Subject: UNIVERSITY VILLAGE AT LAKE DESIGN

ALTERNATE BUILDING/OPEN SPACE DESIGN
UNIVERSITY VILLAGE AT LAKE
JUNE 2017

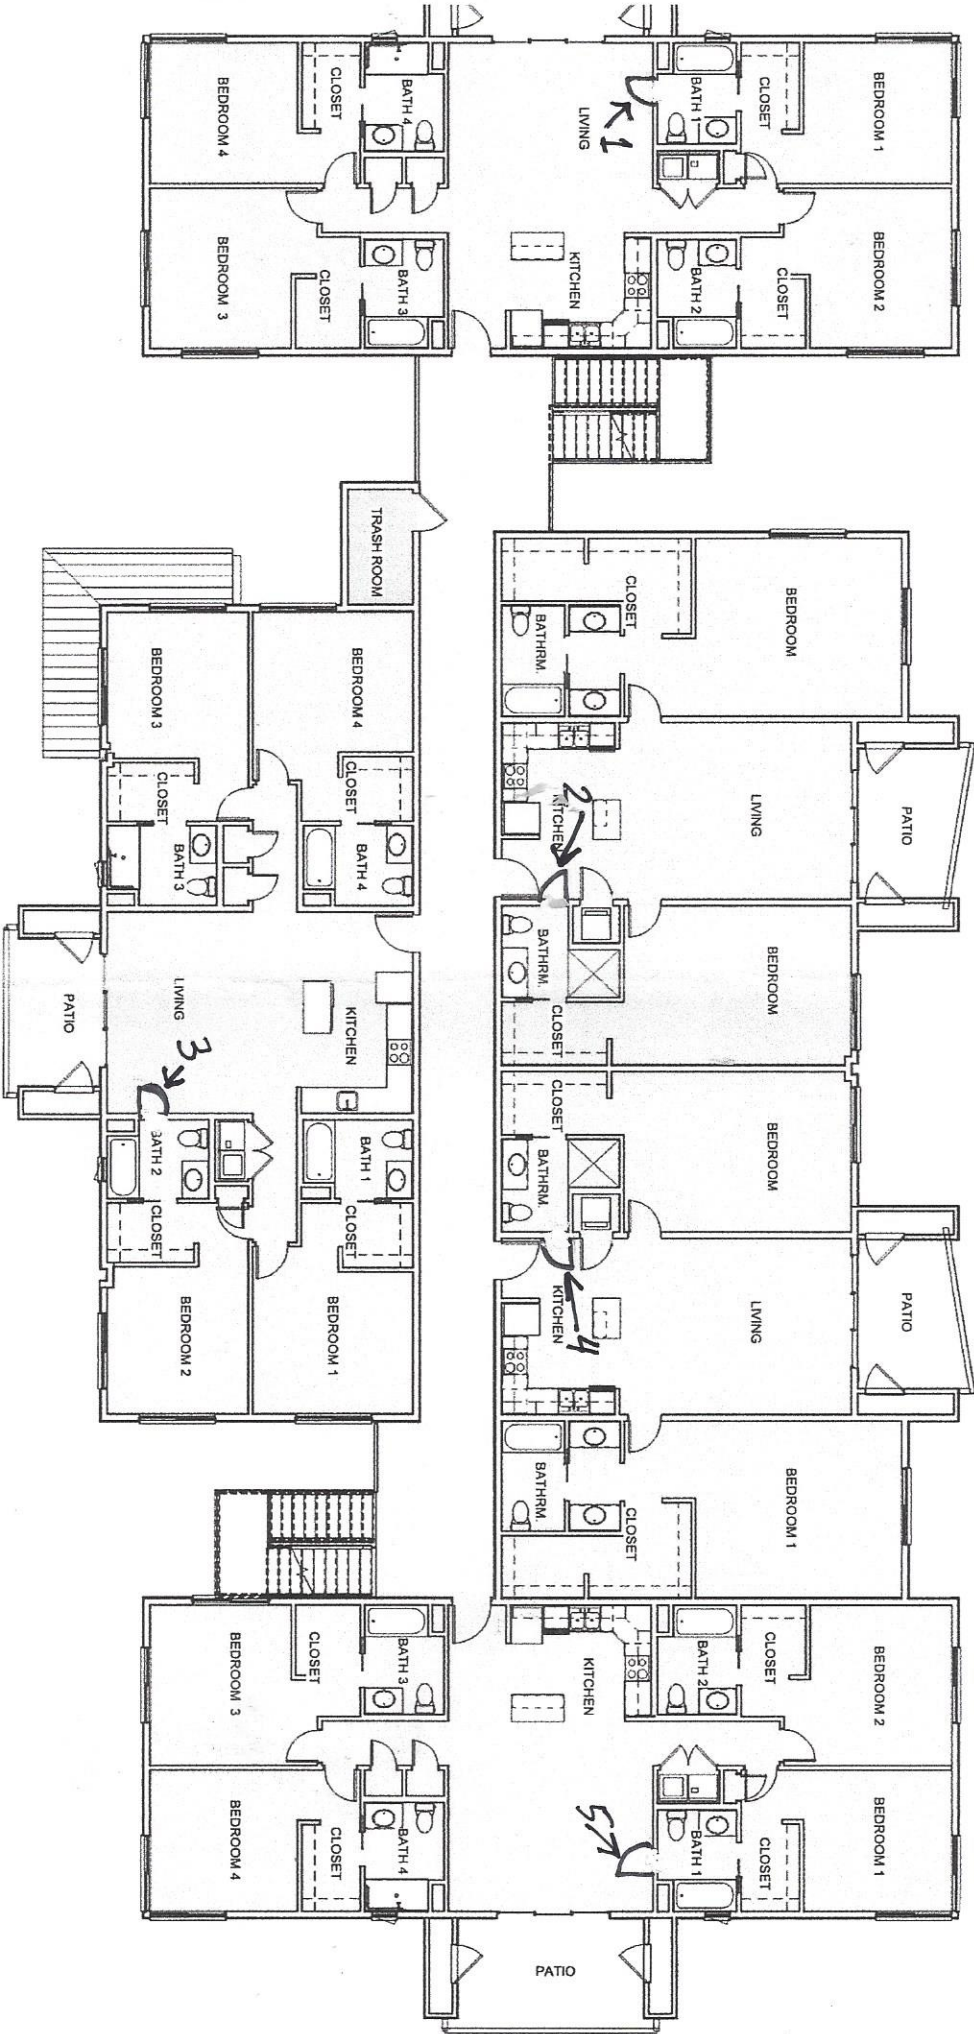
The first change is to achieve clustering of apartment buildings into groups that have an adjacent open space that seems like it belongs to those apartments. This improve security, safety, and development of neighbor relations that are better for residents. The current design north of the club house looks like "human filing cabinets". Buildings in a row with no relation to an outdoor space, focal point, or gathering place near to and unique to those buildings. The alternate design incorporates courtyards A, B, & C in addition to the pool clubhouse gathering area. It also relocates the basketball court so it is surrounded by apartments rather than at the far end of the complex away from most apartments that might use it. This is in keeping with the new zoning ordinance design guidelines for apartments. The developer should be complimented for following the guideline to provide every unit with a balcony. More improvements can be made.

The second change is to improve the solar exposure so that balconies and windowed rooms have good sunlight without glare and excess heat gain. In the original design seven (7) of the apartment buildings face east-west, so that they have glaring hot sun in the afternoon or morning coming in at a low angle. This makes balconies less useable. In the design alternative only three of the buildings face east-west while the other 12 face generally north-south. North-south facing windows and balconies receive sunlight but in the summer the angle of the sun is high so roof overhangs create shade successfully. In the winter when the sun is low in the sky the south facing units receive sunlight during a cold and dark time of the year, thereby improving the living environment.
